# UNITED STATES PATENT AND TRADEMARK OFFICE

APPLICATION NO.	FILING DATE	FIRST NAMED INVENTOR	ATTORNEY DOCKET NO.	CONFIRMATION NO.
10/730,021	12/09/2003	Andreas Obrebski	0902-009	2756

## Office Action Summary

## **DETAILED ACTION**

Fig. 1

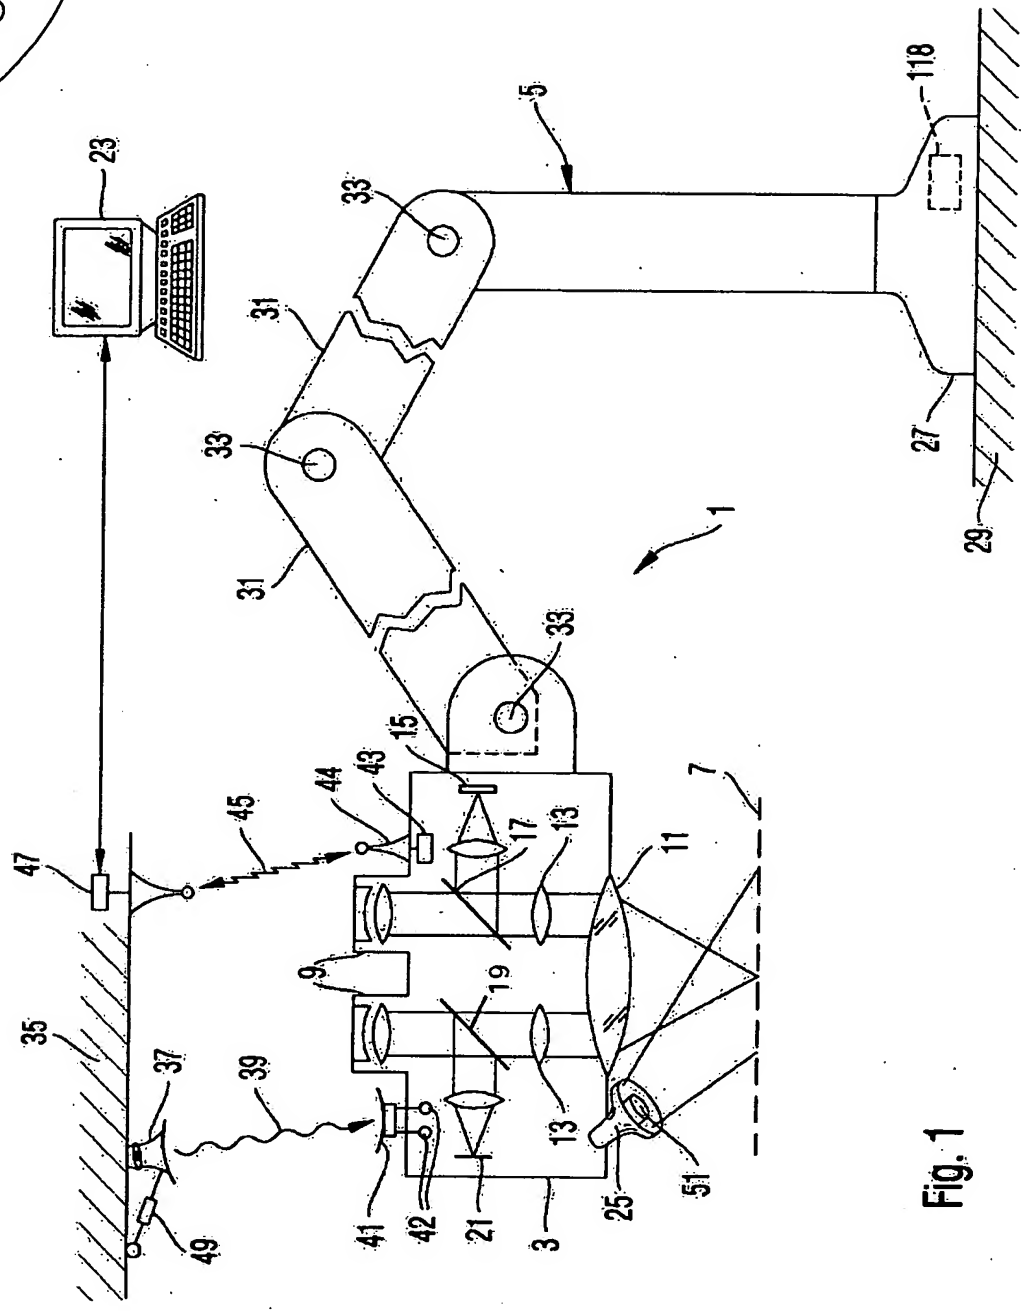
2. The replacement sheet contains corrected figure 1 was received on 8/7/2006. The replacement sheet having corrected figure 1 is approved by the Examiner.

3. The objections to the drawings as set forth in the previous Office action are overcome by the amendments to the drawings and the specification as provided in the amendment filed by applicant on 8/7/2006.

Entirety approved  
10/13/06
